Product Change Notice (PCN)

PCN Number: PCN-65690916R-01

Product(s) Affected: V78-500-SMT series and V78-1000-SMT series

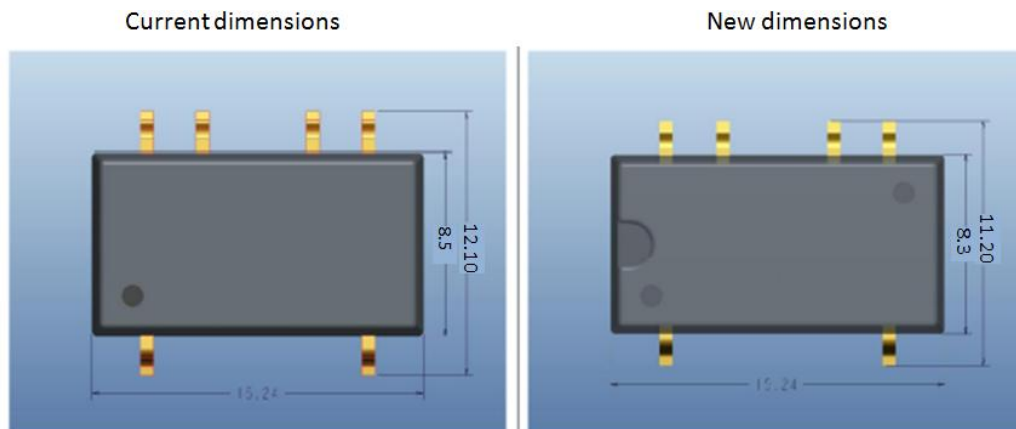
Description of Change: The V78-500-SMT and V78-1000-SMT series have been updated with minor changes in packaging to accommodate manufacturing process improvements.

The primary changes are to package width from 8.50mm to 8.30mm (including pins changed from 12.10mm to 11.20mm).

The new design will be distinguished with a semi-circle for the pin-orientation marking.

Additional Information: Existing PCB layouts should not be affected by the change. Testing has shown backward compatibility to the current recommended PCB layout.
